**CITY OF ALBUQUERQUE  
PLANNING DEPARTMENT  
February 20, 2013  
DRB Comments**

**PROJECT # 1009593**

**APPLICATION # 13-70446**

**RE: Lot 5, Block 6, Volcano Cliffs Subdivision, Unit 18**

PROPOSED LOT SPLIT  
 SITUATE WITHIN LOT 41, BLOCK 6  
 UNIT 18  
 VOLCANO CLIFFS SUBDIVISION

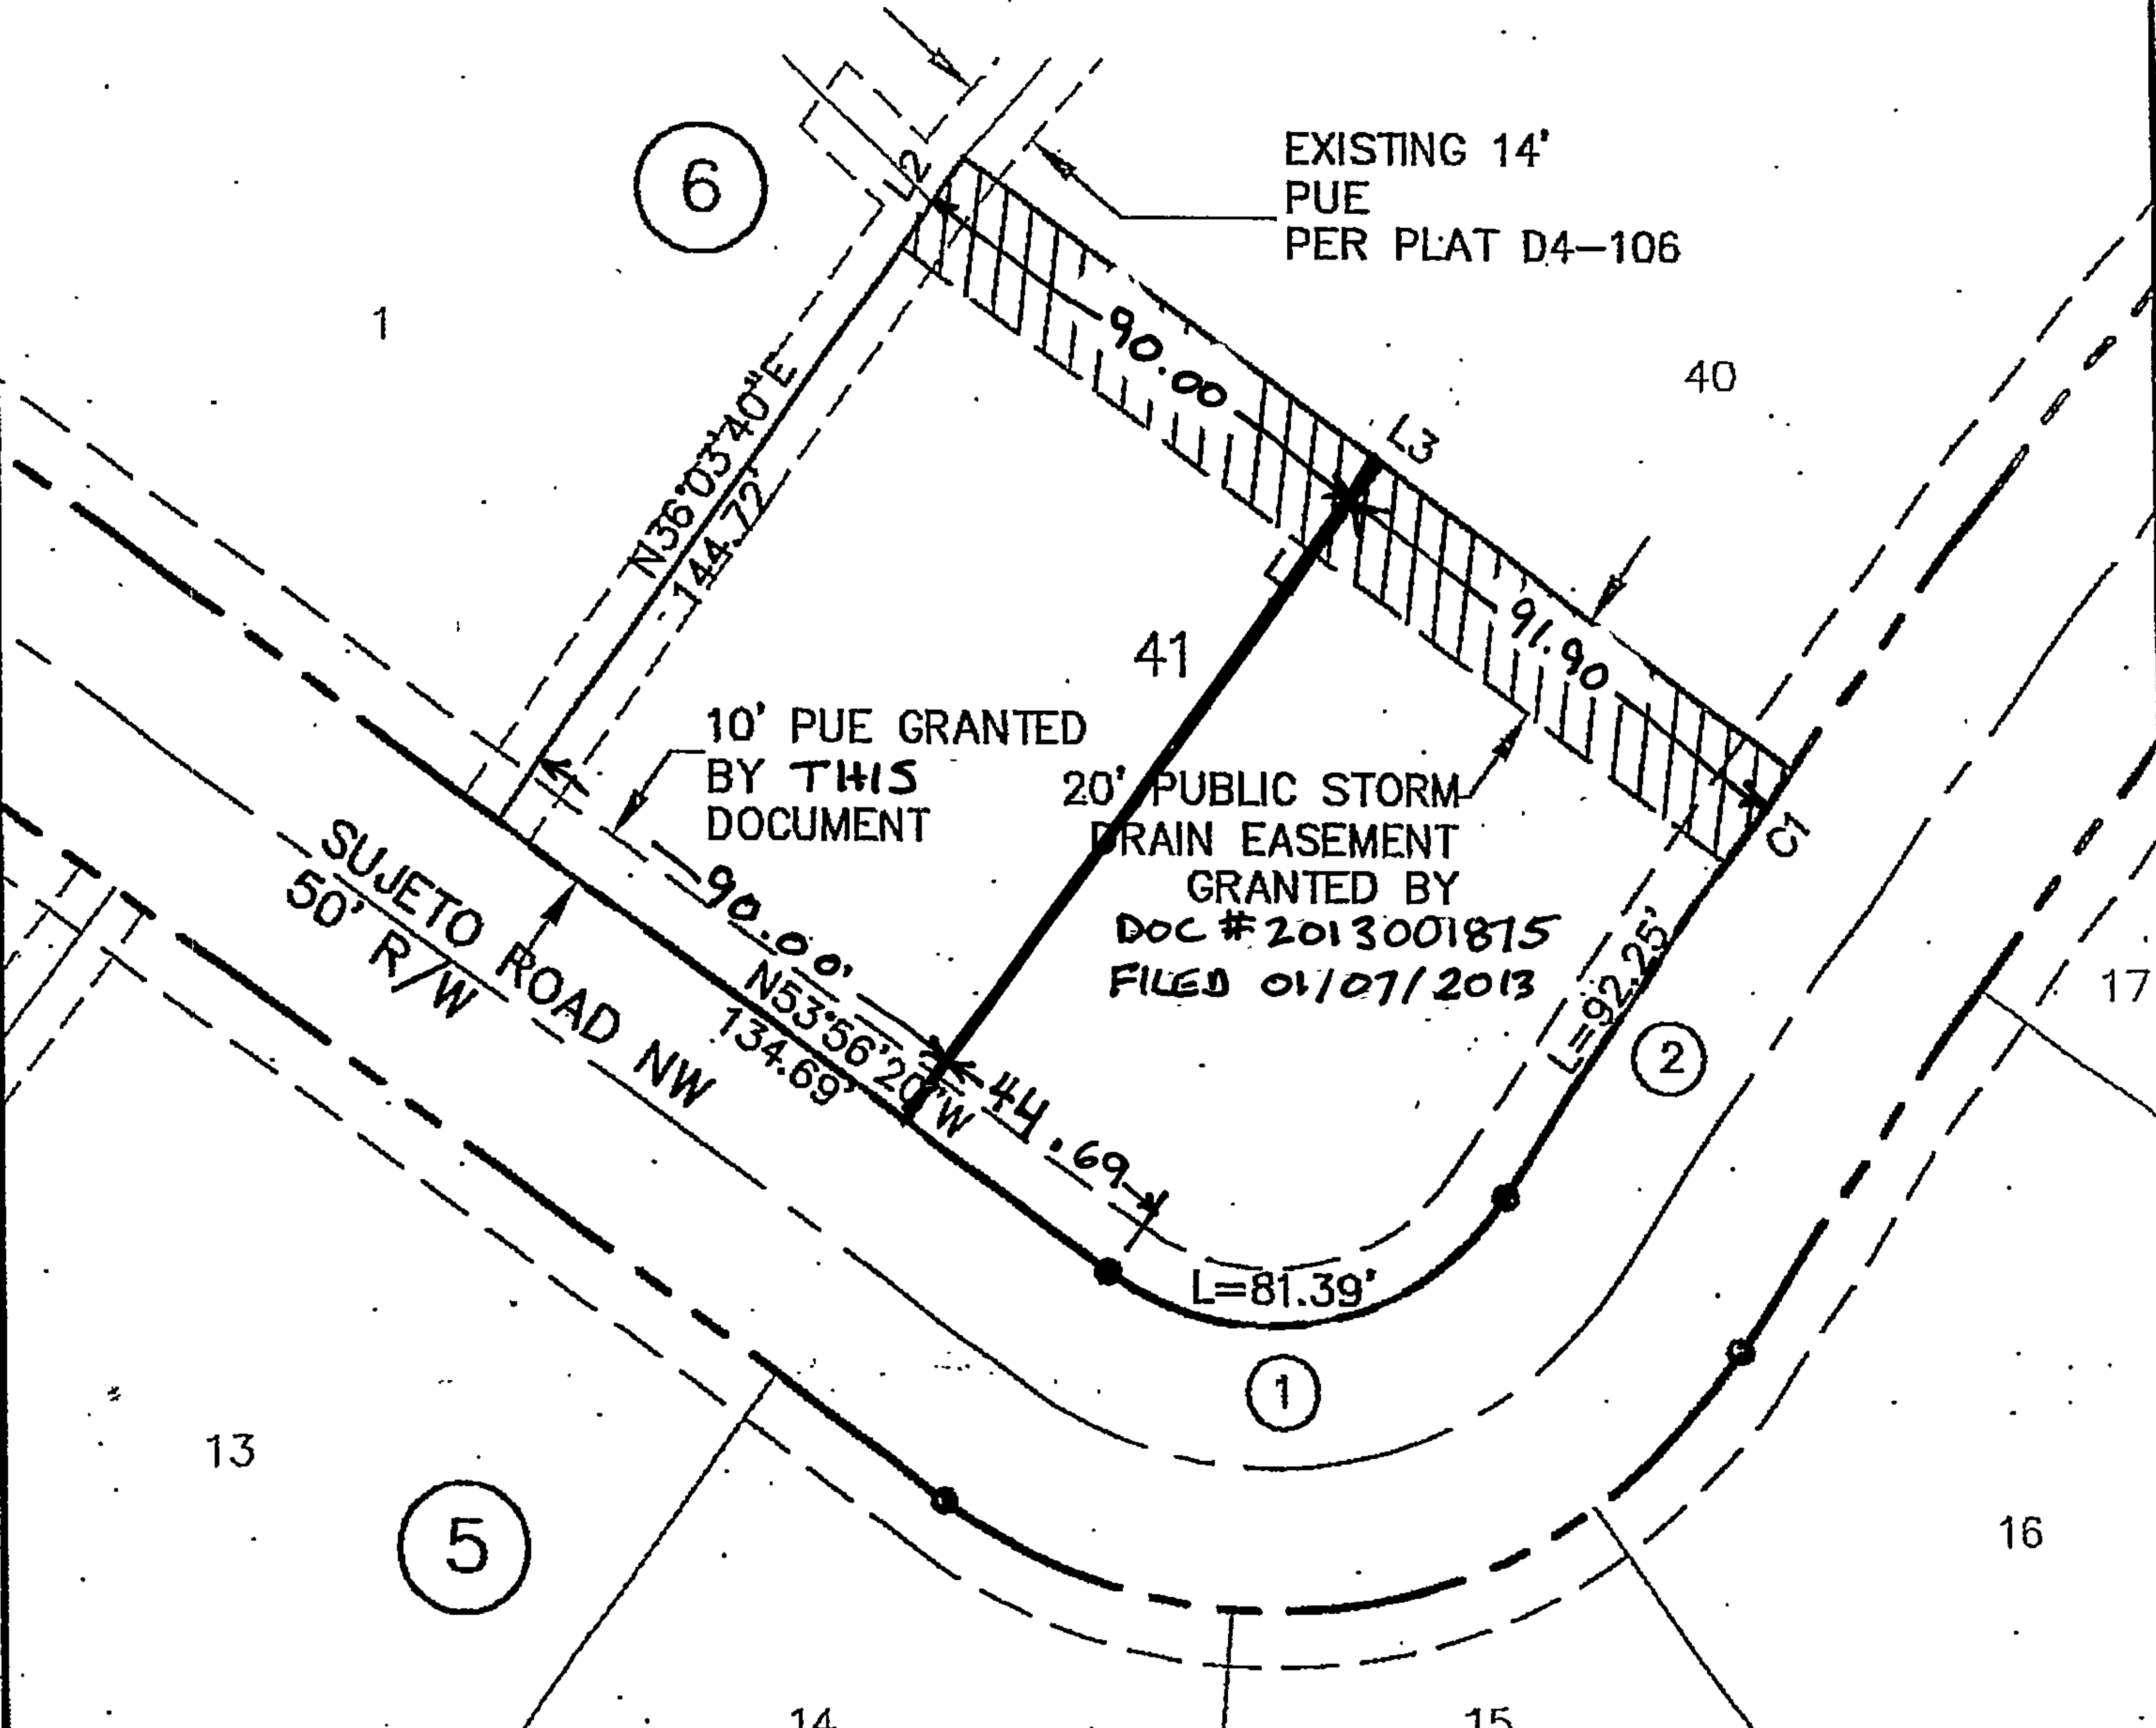
The application is incorrect – this site is in Unit 18 (not 22).

This site is zoned SU-2 VCLL; refer to the Volcano Cliffs Sector Development Plan and the NW Mesa Escarpment Plan/ Impact Area for development standards (e.g. 25 ft front setback and 15 ft for each side and rear, building articulation, building height, landscaping etc.).
